SHERIDAN SUBDIVISION

APPLICATION NUMBER 3 DATE October 4, 2018

REQUEST Subdivision

DETAIL SITE PLAN

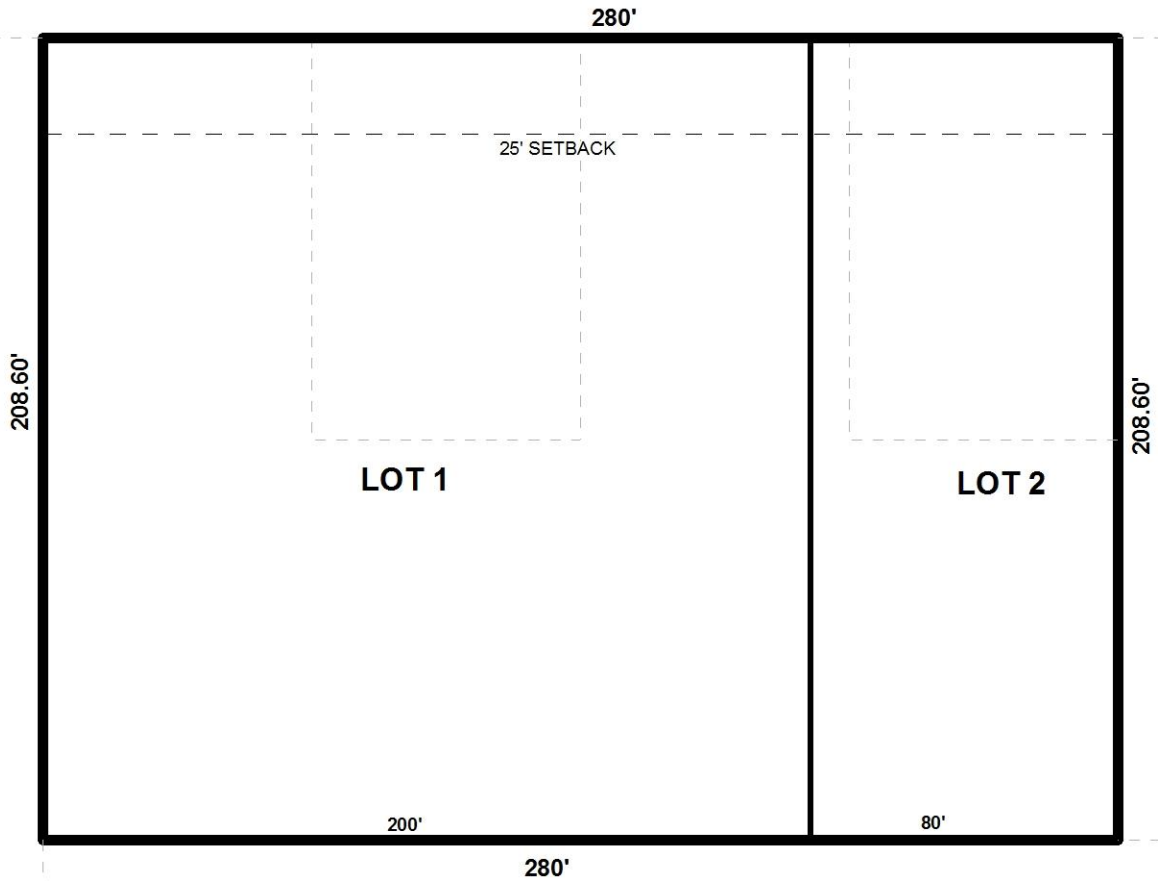
The proposed lots have frontage along Spring Hill Avenue, a major street with curb and gutter requiring a 100' right-of-way, per the recently adopted Major Street Plan. The preliminary plat illustrates a 70' right-of-way and should, therefore, if approved, be revised to provide dedication 50' from the centerline of Spring Hill Avenue.

The 25' minimum building setback line is illustrated along Spring Hill Avenue, in compliance with Section V.D.9. of the Subdivision Regulations, and should be retained on the Final Plat, if approved, and adjusted for dedication.

It should be noted that, as a result of dedication, the existing structure on proposed Lot 2 may encroach on the adjusted 25' minimum building setback by 10'±, and should be considered non-conforming as a result of the Subdivision request, if approved. However, all future construction must meet the minimum setback requirements of both the Subdivision Regulations and the Zoning Ordinance.

- 1) revision of the plat to illustrate dedication sufficient to provide 50' from the centerline of Spring Hill Avenue;
- 2) retention of the lot sizes in square feet and acres on the Final Plat, or provision of a table on the Final Plat providing the same information, either should be adjusted for dedication;
- 3) retention of the 25' minimum building setback line along Spring Hill Avenue, adjusted for dedication;
- 4) compliance with Engineering comments: (FINAL PLAT COMMENTS *(should be addressed prior to submitting the FINAL PLAT for review and/or signature by the City Engineer): A. Provide all of the required information on the SUBDIVISION PLAT (i.e. signature blocks, signatures, certification statements, written legal description, required*
